State of New Mexico
 Energy, Minerals and Natural Resources

Form C-103
 Revised July 18, 2013

WELL API NO. 30-045-23791
5. Indicate Type of Lease STATE <input type="checkbox"/> FEE <input checked="" type="checkbox"/>
6. State Oil & Gas Lease No.
7. Lease Name or Unit Agreement Name LANDAUER
8. Well Number 1E
9. OGRID Number 372171
10. Pool name or Wildcat Basin Dakota/Blanco Mesaverde

From: Diede, Loren, EMNRD <Loren.Diede@emnrd.nm.gov>
Sent: Wednesday, September 11, 2024 3:40 PM
To: John LaMond; Kuehling, Monica, EMNRD; Medrano, Eileen, EMNRD
Cc: Farmington Regulatory Techs; Clay Padgett; Lee Murphy; Rustin Mikeska; Oscar Sanchez - (C)
Subject: RE: [EXTERNAL] P&A Revision Request for Hilcorp's LANDAUER 1E (API # 3004523791)

Current Schematic - Version 3

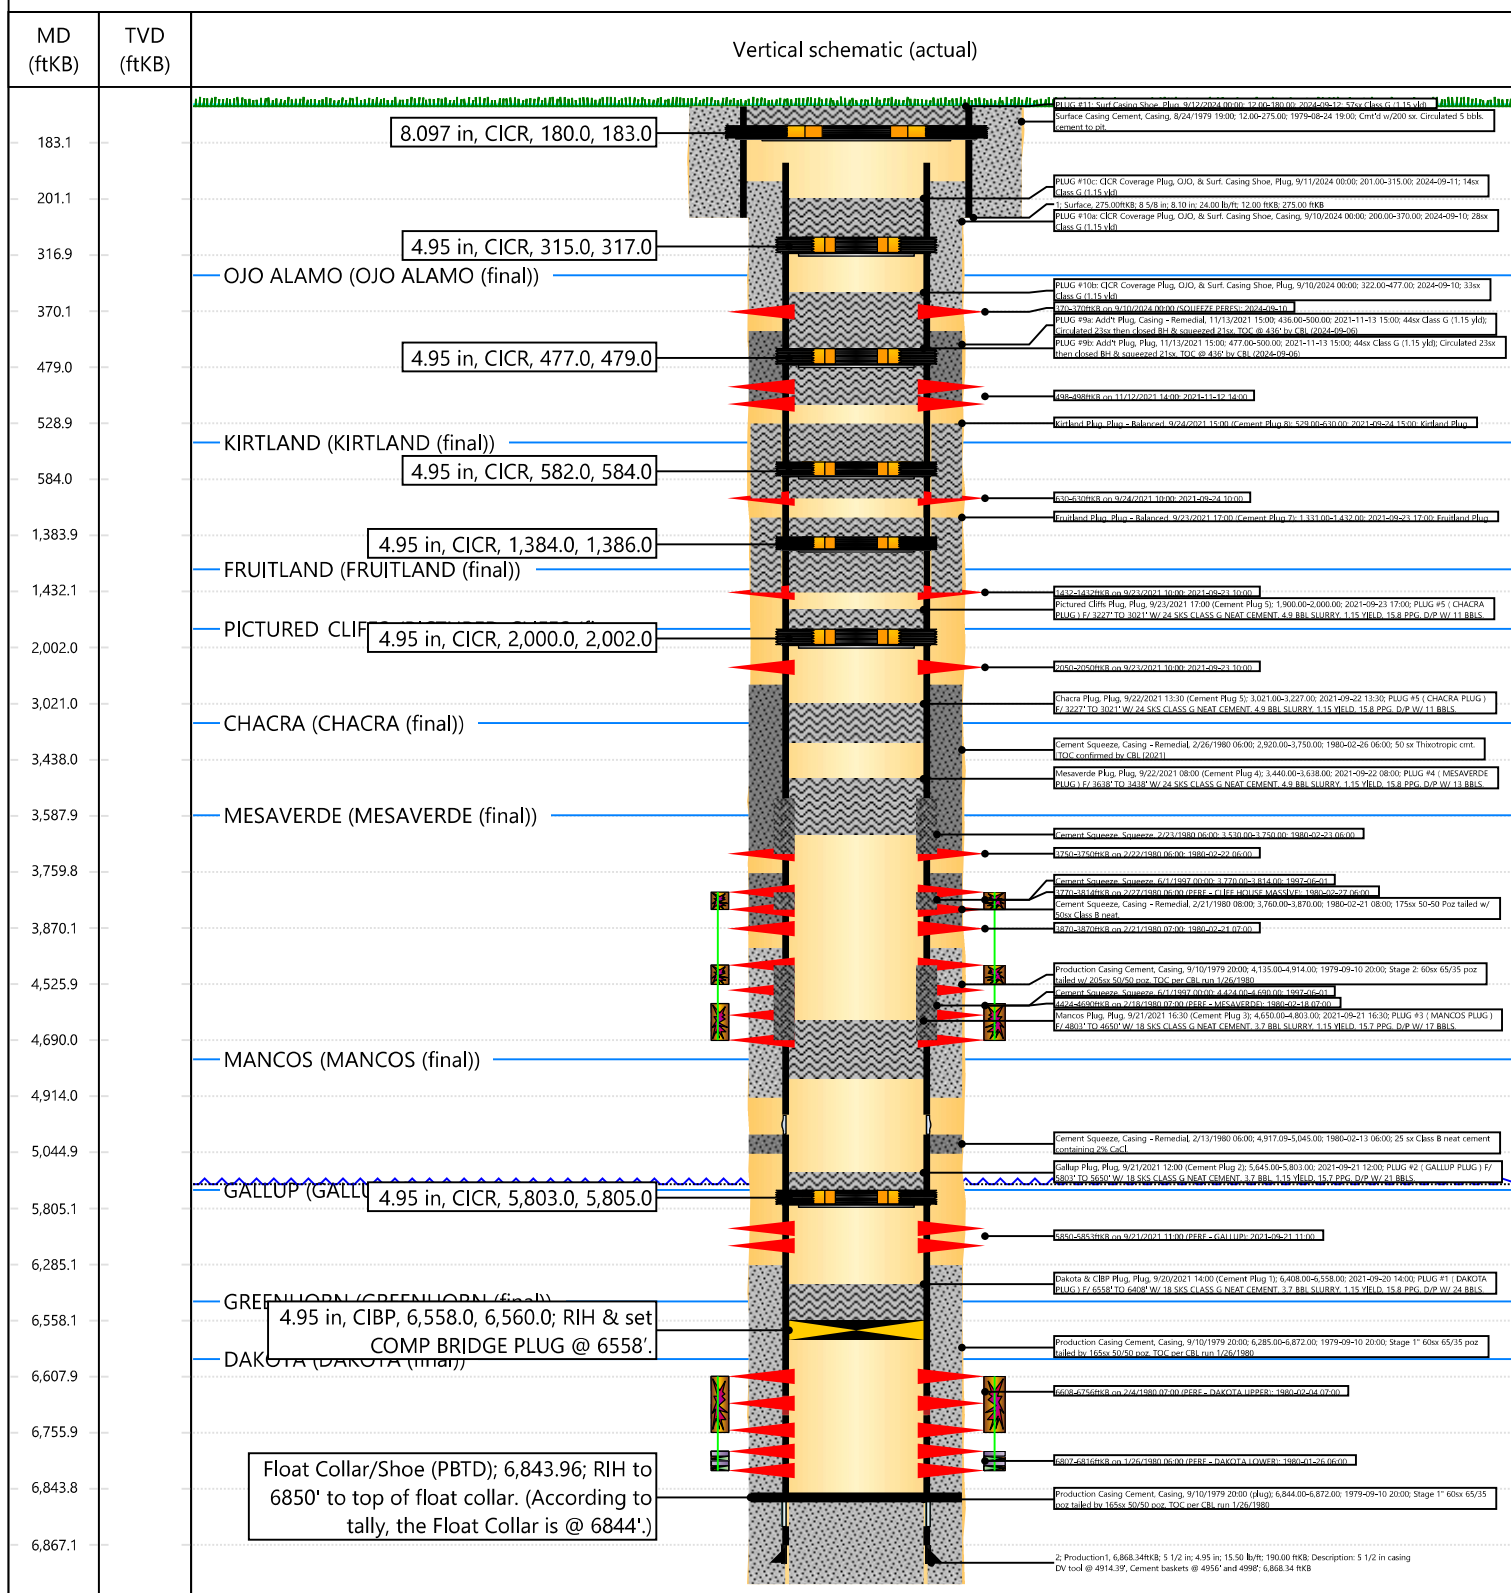
Per our discussion, Hilcorp perforated @ 370' & pumped PLUG #10 per design outlined below. We then WOC overnight and shut in both the BH & 5-1/2" casing.

This morning we found that there was no pressure on the BH nor the 5-1/2" production casing. We also tagged the TOC @ 322' inside the 5-1/2".

- Set a **5-1/2" CICR @ 315'**
- **Pump PLUG #10b: 15sx of Class G Cement (15.8 PPG, 1.15 yield); OJO Top @ 320' | Surf. Casing Shoe @ 275':**
 - Pump a 14 sack balanced cement plug inside the 5-1/2" casing (est. **TOC @ +/- 200'** & est. **BOC @ +/- 315'**).
 - WOC & tag TOC
- **Jet cut the 5-1/2" production casing 10' above cement tag depth @ +/- 190'. TOOH w/ 5-1/2" production casing.**
- RIH w/ **8-5/8" CIBP or CICR** & set @ **+/- 180'**.
- **Pump Plug #11: 56sx of Class G Cement (15.8 PPG, 1.15 yield)**
 - Pump a 56 sack balanced cement plug inside the **8-5/8"** casing (est. **TOC @ +/- 0'** & est. **BOC @ +/- 180'**)
 - WOC, cut off wellhead & top off w/ cement

Per our discussion, Hilcorp received verbal approval from the NMOC to make the following adjustments:

- RIH & perforate squeeze holes @ 370'. Establish circulation to surface.
- RIH w/ work string & tag CICR @ 477'. Establish circulation to surface.
- **Pump PLUG #10: 61sx of Class G Cement (15.8 PPG, 1.15 yield); OJO Top @ 320' | Surf. Casing Shoe @ 275':**

- Pump 15sx of cement in the 5-1/2" casing X 7-7/8" open hole annulus (est. **TOC @ +/- 275'** & est. **BOC @ +/- 370'**). Continue pumping 13sx of cement in the 5-1/2" casing X 8-5/8" casing annulus (est. **TOC @ +/- 200'** & est. **BOC @ +/- 275'**). Pump a 33 sack balanced cement plug inside the 5-1/2" casing (est. **TOC @ +/- 200'** & est. **BOC @ +/- 477'**).

- **Pump PLUG #11: 55sx of Class G Cement (15.8 PPG, 1.15 yield)**
 - Pump 32sx of cement in the 5-1/2" casing X 8-5/8" casing annulus (est. **TOC @ +/- 0'** & est. **BOC @ +/- 190'**). Continue pumping a 23 sack balanced cement plug inside the 5-1/2" casing (est. **TOC @ +/- 0'** & est. **BOC @ +/- 190'**).

- WOC, cut off wellhead & top off w/ cement
 - If BH pressure is present, verbal approval received from the NMOCD for the following:
 - **Jet cut 5.5"** production casing 10' above cement tag depth @ **+/- 190'**. TOOH w/ 5.5" production casing.

- RIH w/ **8-5/8" CIBP or CICR** & set @ **+/- 180'**.
 - **Pump Plug #11: 56sx of Class G Cement (15.8 PPG, 1.15 yield)**
 - Pump a 56 sack balanced cement plug inside the 5-1/2" casing (est. **TOC @ +/- 0'** & est. **BOC @ +/- 180'**)

That plan is OK with me.

As per our discussion and the email outlining the path forward on the Landauer 1E P&A. I approve the plan as outlined here below.

Approval is given to below
